Access Compliance Report

Public Rights-of-Way

(Curb Ramps)

Intersection ID: 10027864	Main Street: HAMILTON_ST	Cross Street: N/A	Location: NW
ADA ID: 68843E175103	Ramp Type: Perp	Initial Pass/Fail: Fail	Overall Compliance: No
Severity Score: 13.75			
Codes/Mitigation Info/Possible Solution		Field Measurements/Component Compliance

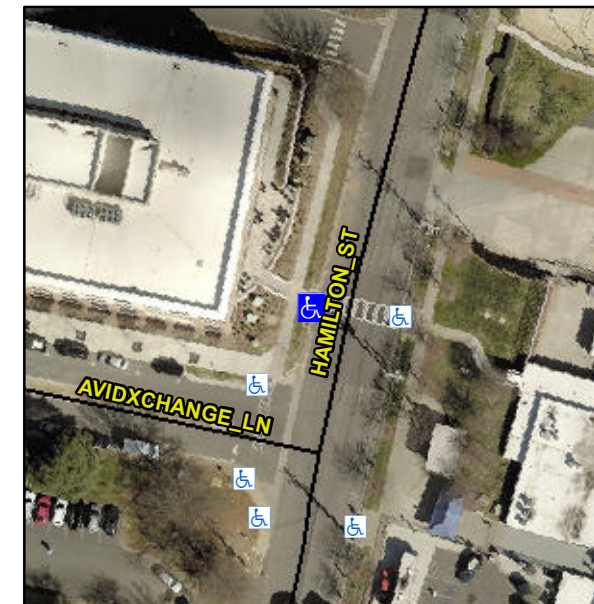
Not Found, R304.2.2

Compliance	Description	Data	Compliance	Description	Data
N/A	Ramp Length (in)	71.0	No	Ramp Slope (%)	9.9
Yes	Ramp Width (in)	72.0	Yes	Ramp XSlope (%)	2.9
N/A	Flare Type LT	N/A	N/A	Flare Type RT	N/A
N/A	Flare Slope LT (%)	N/A	N/A	Flare Slope RT (%)	N/A
N/A	Flare Traversable LT?	N/A	N/A	Flare Traversable RT?	N/A
N/A	Landing Length (in)	N/A	N/A	DWS Provided?	N/A
N/A	Landing Width (in)	N/A	N/A	DWS Contrast?	N/A
N/A	Landing Slope (%)	N/A	N/A	DWS Length (in)	N/A
N/A	Landing X Slope (%)	N/A	N/A	DWS Full Width?	N/A
N/A	Landing Curb? (Y/N)	N/A	N/A	DWS Offset (in)	N/A
N/A	Shared Landing?	N/A			
N/A	Gutter Ponding?	N/A	N/A	Gutter Slope (%)	N/A
N/A	Gutter Lip Ht (in)	N/A	N/A	Gutter X Slope (%)	N/A
N/A	Painted X Walk1?	Yes	N/A	Painted X Walk2?	N/A
	X Walk 1 Direction	To E		X Walk 2 Direction	N/A
N/A	X Walk 1 Width (in)	104.0	N/A	X Walk 2 Width (in)	N/A
	X Walk 1 Slope (%)	3.4		X Walk 2 Slope (%)	N/A
	X Walk 1 X Slope (%)	3.2		X Walk 2 X Slope (%)	N/A

Remove & Replace Entire Ramp.
